# Final QA/QC Report

2017 LIDAR QA/QC FOR COASTAL TEXAS  
STATEMENT OF WORK #580170040

TEXAS WATER DEVELOPMENT BOARD

April 4, 2018

*Figure 3 – LiDAR Planned Flight lines (Black) overlaid As-Flown Trajectories (Green)*

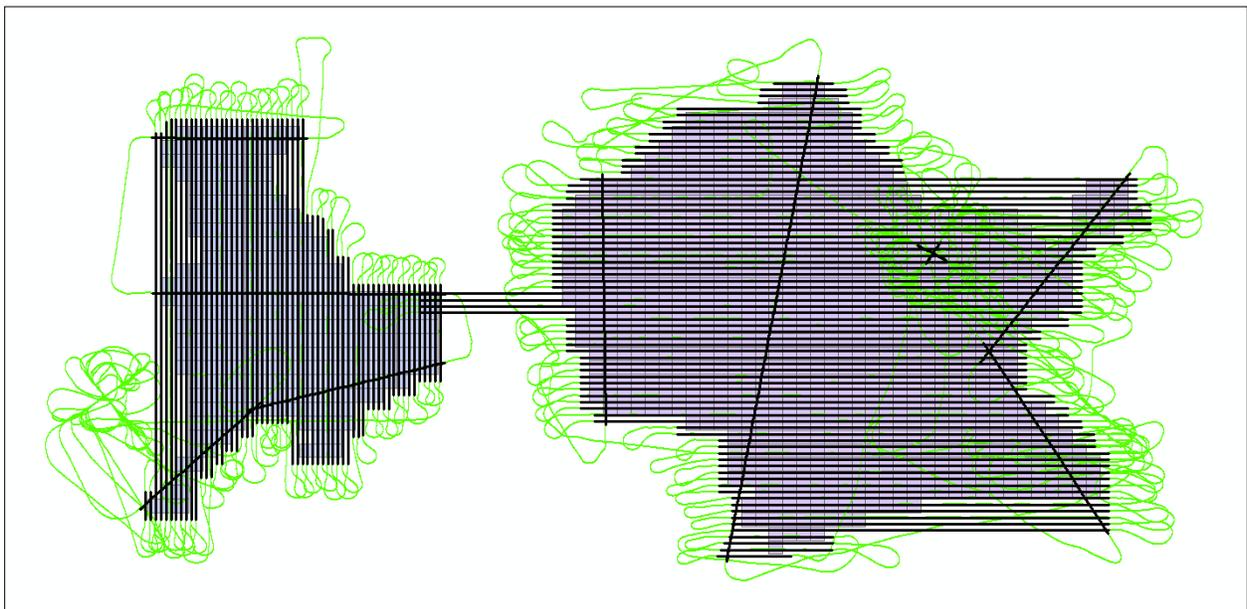
The trajectory data captured from the aircraft's GPS, collected at 0.5 second intervals, were compared against the planned flight plans. A comparison of the planned flight lines and trajectories as they were flown are below. The as-flown data aligned well with the planned datasets.

Figure 4 - Sanborn LiDAR Planned Control Locations (X) and Actual Control Locations (▲)

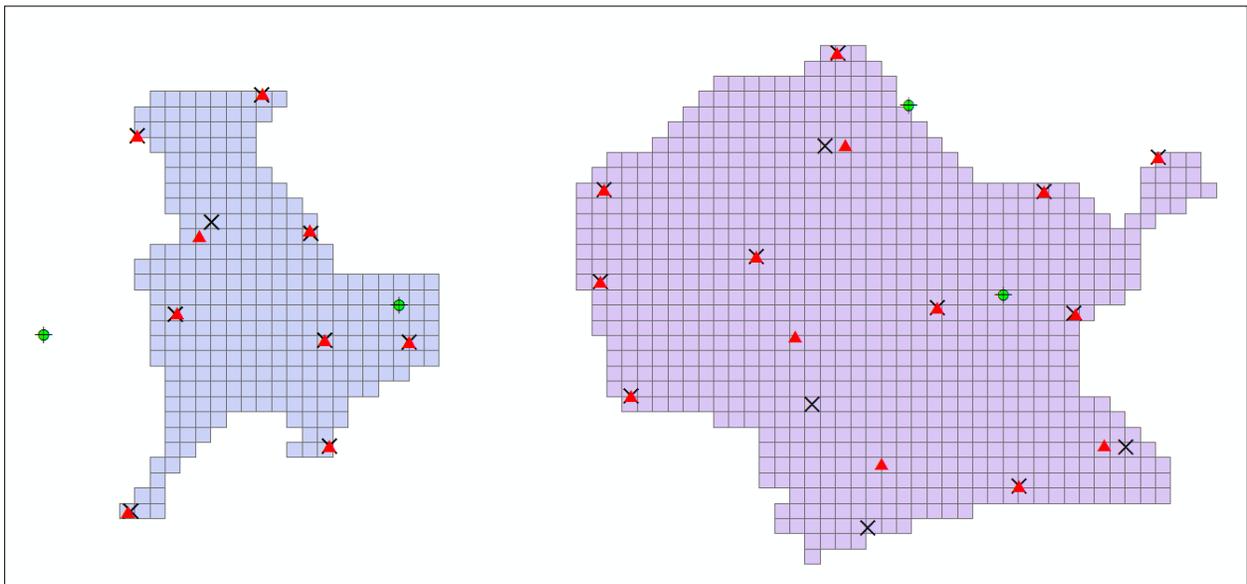
Survey points were evenly spaced, well dispersed, and for the most part closely mimic the planned control point locations, as can be seen in the graphic below. Two control points in the East AOI are shifted ~5 miles from their planned positions.

Figure 5 CP 1109 excused (left)  
Figure 6 CP 1120 excused (right)

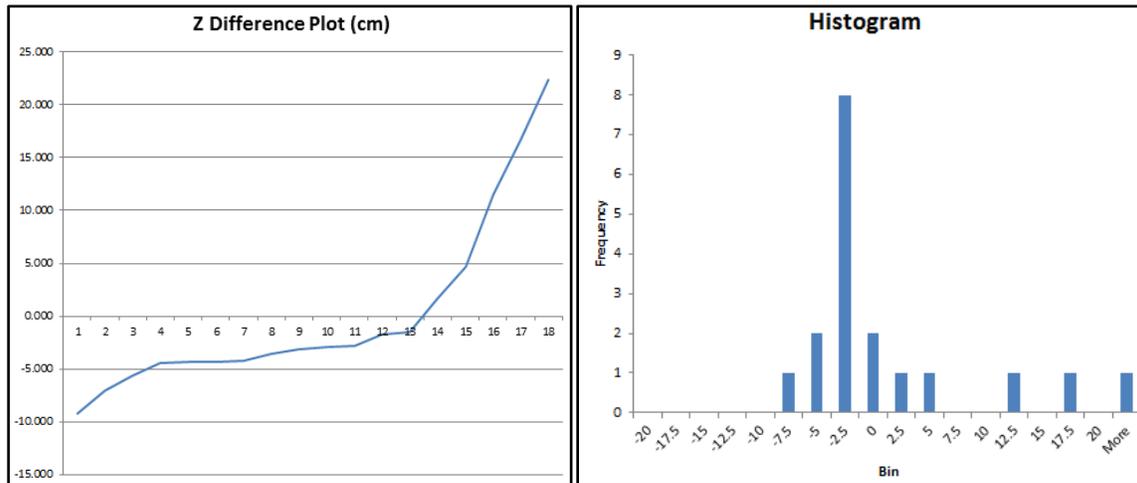
20 NVA checkpoints were run against the data as part of the initial accuracy check. The results identified two checkpoints with deltas larger than expected which warranted further review (points 1109 and 1120). As reported as part of the initial Phase III report, excerpt below, these points were determined to be blunders and excused from the overall accuracy calculation.

- *Point 1120 proximity of surveyed point to culvert may impact vertical results*
- *Point 1109 appears to rest on a sloping and what may be an actively eroding surface which may impact vertical results*

Removal of points 1120 and 1109 resulted in an RMSEz of 8.252 cm using 18 checkpoints. This result is within the USGS QL1  $\geq 8$  PPSM absolute accuracy requirements.

Figure 7 CP 1121 excused

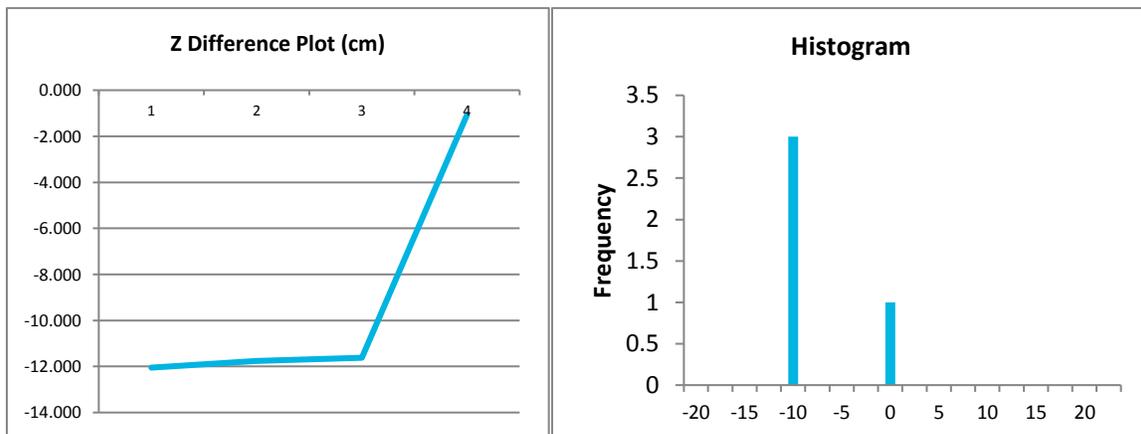
Similar to the NVA assessment above, and as reported as part of the initial Phase III report, excerpt below, checkpoint 1121 was excused from the overall accuracy calculation.

- Point 1121 appears to rest on sloping terrain which may impact vertical results
